**From:** Karina Ruiz [KarinaR@dowa.com]  
**Sent:** Friday, October 08, 2010 11:59 AM  
**To:** Spir, Peter; Tim Woodley; Liden, Keith S.  
**Subject:** RE: letter from a neighbor

Re: West Linn-Wilsonville School District  
Development Application for New Primary School  
CUP-10-03

The purpose of this letter is to elaborate upon the potential construction phasing of the proposed new West Linn Primary School (File No. CUP-10-03). The application narrative (p. 4) and supporting plan sheets (LU3.01 and LU3.02) described the potential phasing and identified the portions of the building that might be constructed at a later date.

**LU3.08**

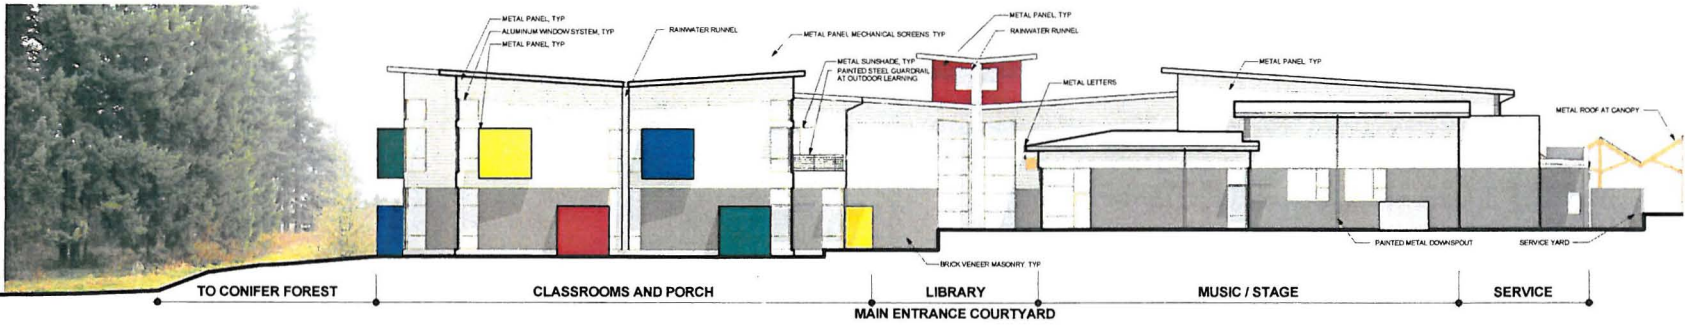
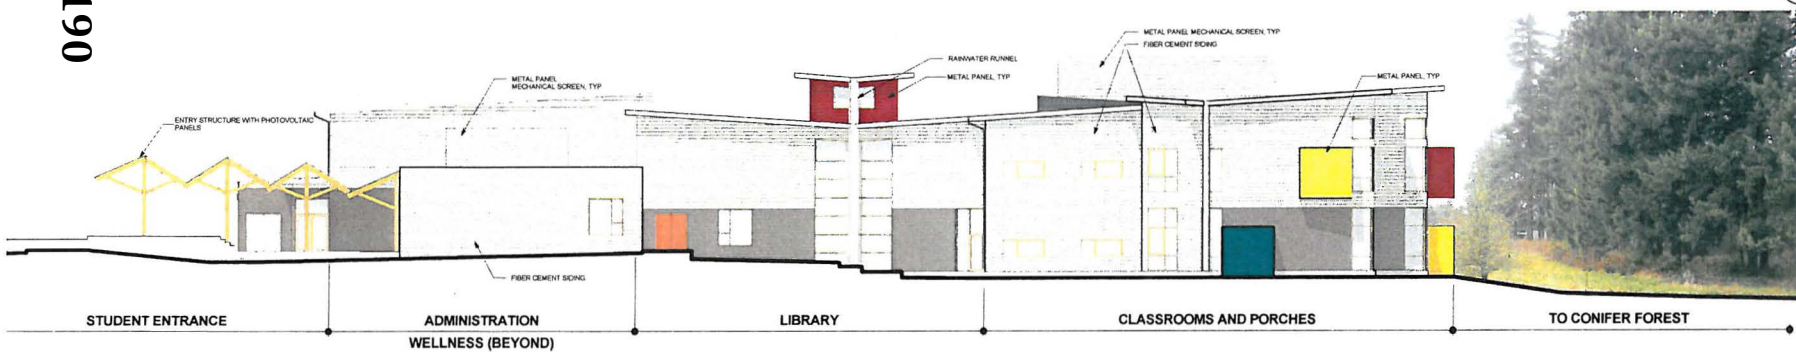
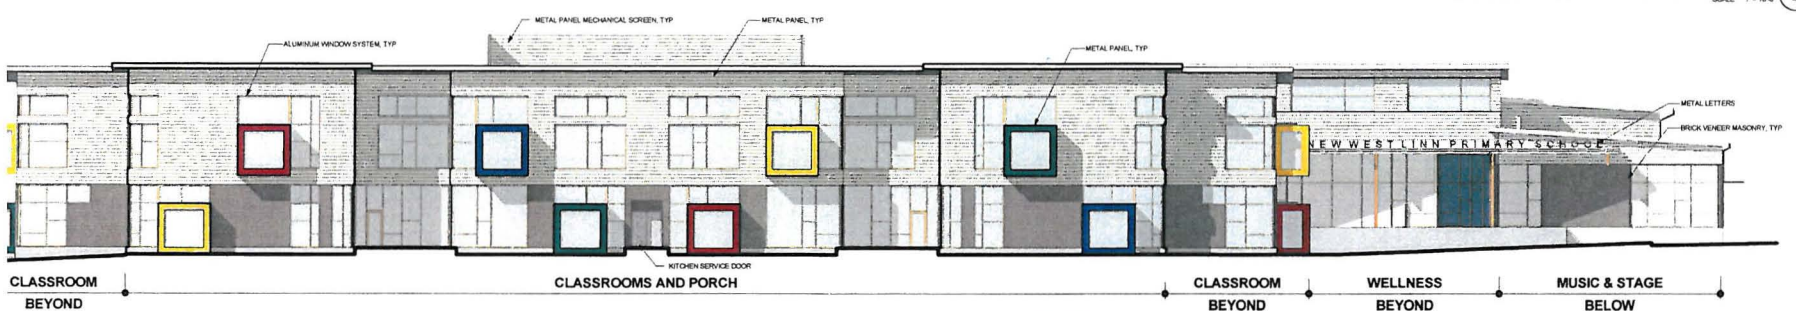
Because portions of the eastern façade would be temporary until the second phase classrooms are added, the district would use less costly siding, which would be removed when the “additive alternate” portions of the building are constructed in Phase 2. The materials will be fiber cement siding painted to match the adjacent metal panel as shown in the attached Sheet LU3.08.

The second phase would include the remaining classrooms to increase the capacity from 350 to 500 students. The temporary siding on portions of the eastern building elevation would be removed to construct the remaining classrooms as shown on the plan sheets.
